SITE PLAN REVIEW AND APPEARANCE BOARD MEMORANDUM STAFF REPORT

Fourth and Fifth Delray

The action before the Board is to consider the Class V Site Plan, Landscape Plan, and Architectural Elevations associated with the Fourth and Fifth Delray (iPic Movie Theater) project.

VEHICULAR CONTROL RADIUS EXHIBIT

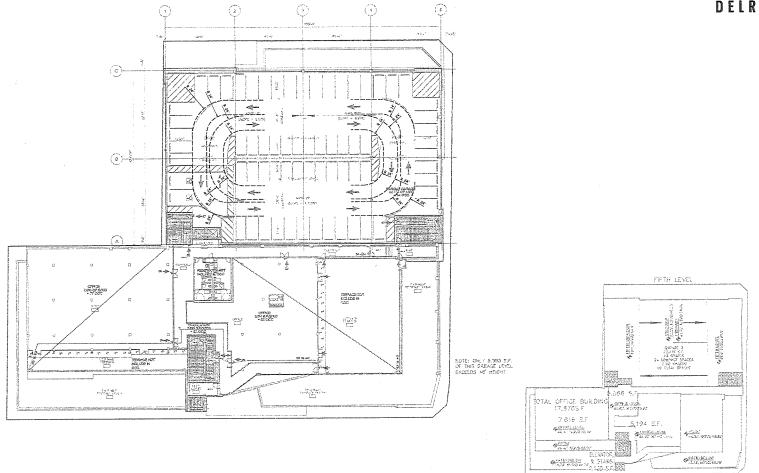
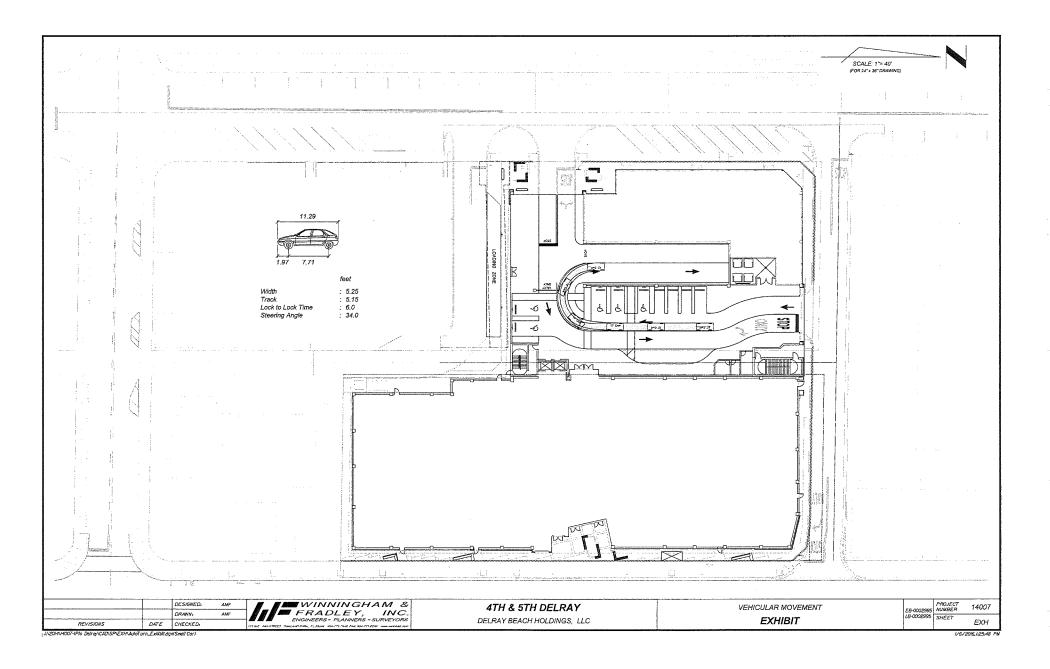
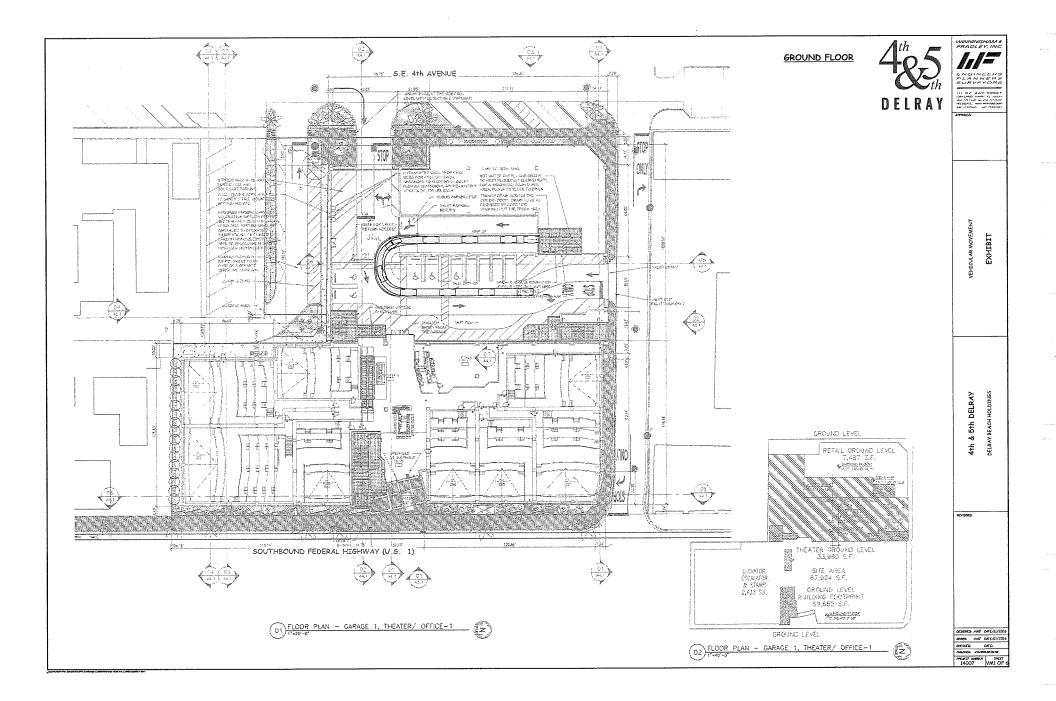
Vehicular Turning:

The revised plans include vehicle turning templates for a passenger vehicle for the ground and upper levels of the garage. These templates indicate that there will be sufficient radii for safe vehicle maneuvering within the parking facility for a 11.29 foot long vehicle with a width of 5.25 feet.
